**Re:** Tallaght/Clondalkin to City Centre BusConnect Core Bus Corridor Scheme.  
Tallaght/Clondalkin to Dublin City.

ABP case ref: 316828

## **BUSCONNECTS TALLAGHT/CLONDALKIN CORE BUS CORRIDOR SCHEME**

Figure 1 Dutch-style junction at Swords Road/Griffith Avenue from the second public consultation

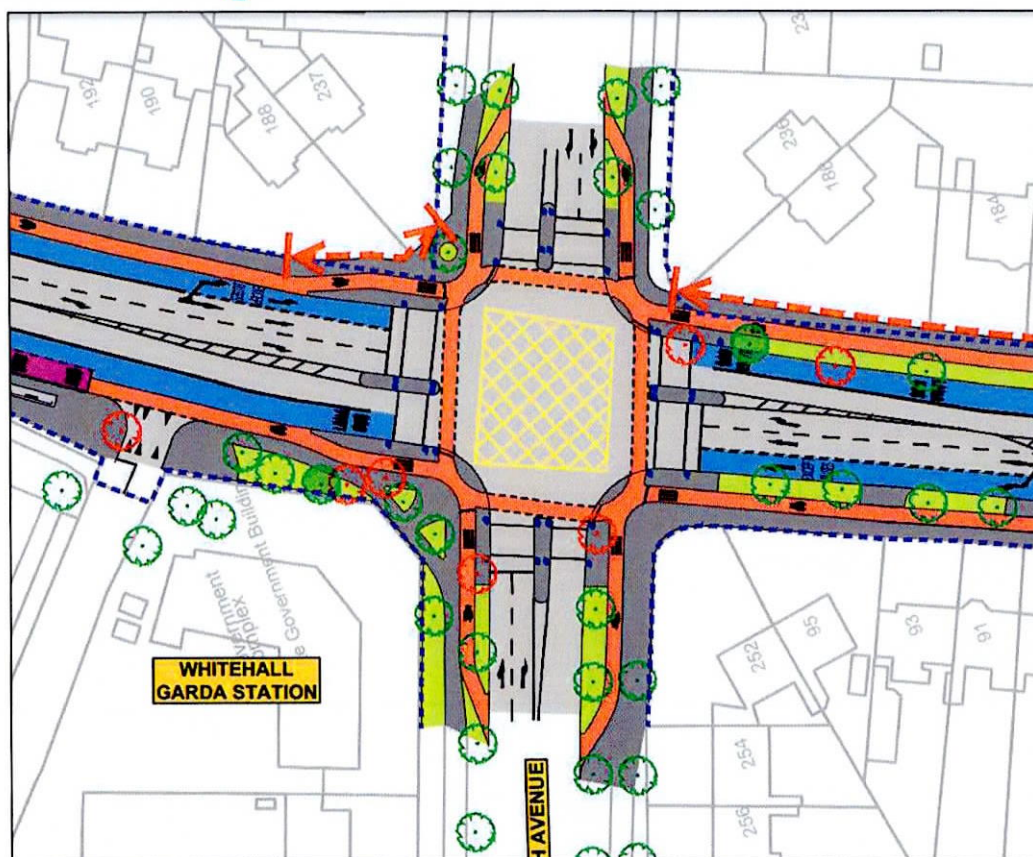
The junction designs in the Proposed Scheme do not follow international best practice in junction design and are widely regarded as unsafe. We request that the NTA use Dutch-style junctions throughout the project.

Figure 2 Cross section at Nicholas Street

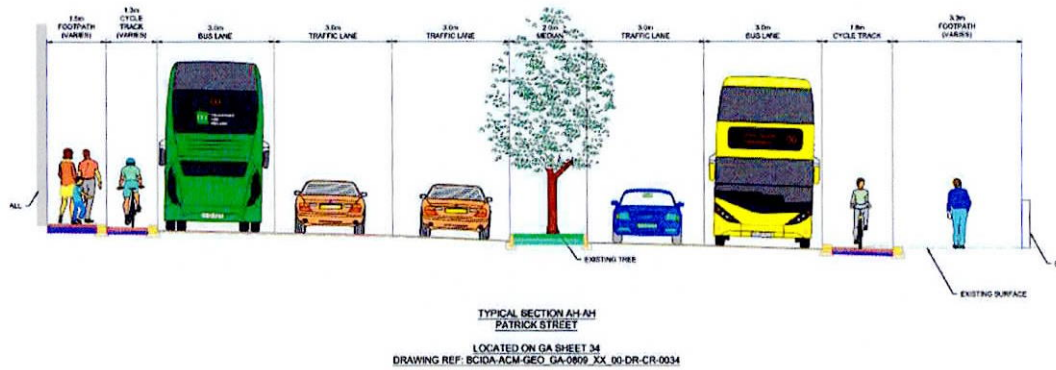
It's inexplicable why the carriageway widens from one inbound general traffic lane to two as Nicholas Street approaches High Street. To facilitate this, the cycle lane is narrowed to a substandard 1.3m and the footpath is narrowed to 1.5m. This is completely unsafe and unsuitable in a city centre location with large numbers of people walking and cycling.

Figure 3 General arrangement of Nicholas Street

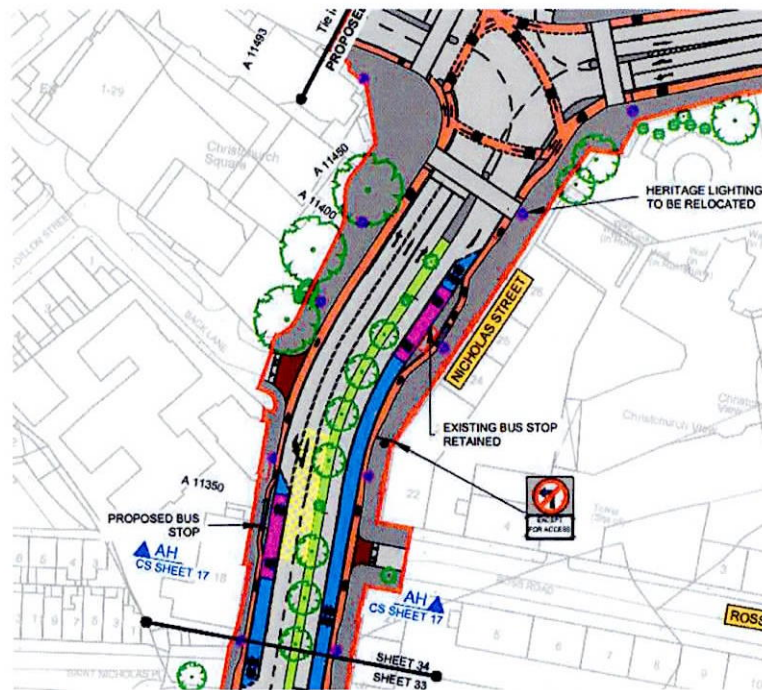
Closer to High Street, bus priority disappears when it's needed the most to facilitate a third general traffic lane. At this city centre location, the scheme prioritises car traffic over public transport, walking and cycling and needs to be redesigned to reflect local and national transport policies.

Figure 4 Naas Road/Long Mile Road junction

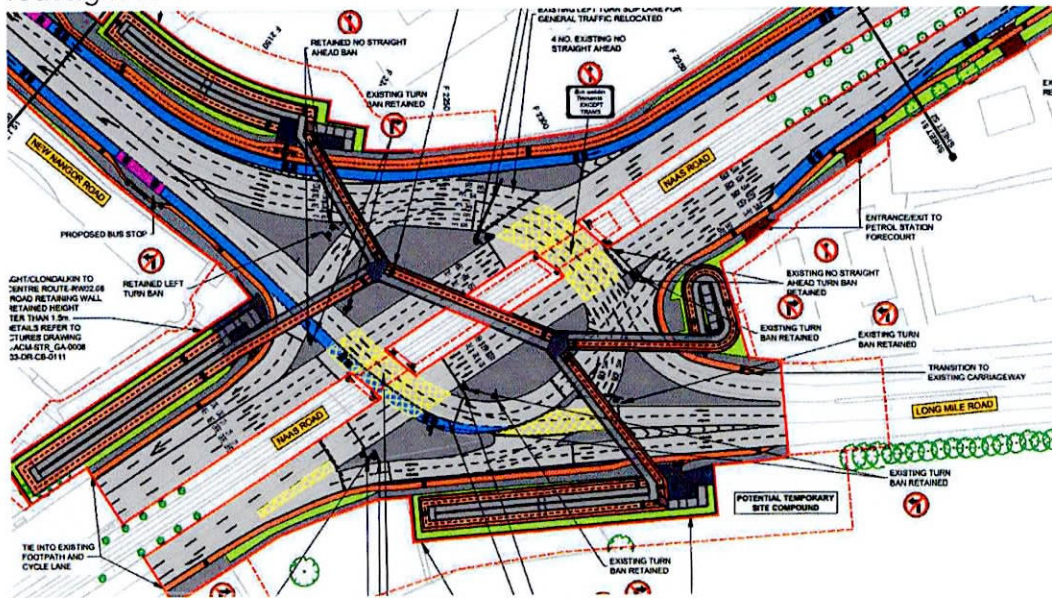
This junction is simply terrible for pedestrians and cyclists and needs to be completely redesigned.
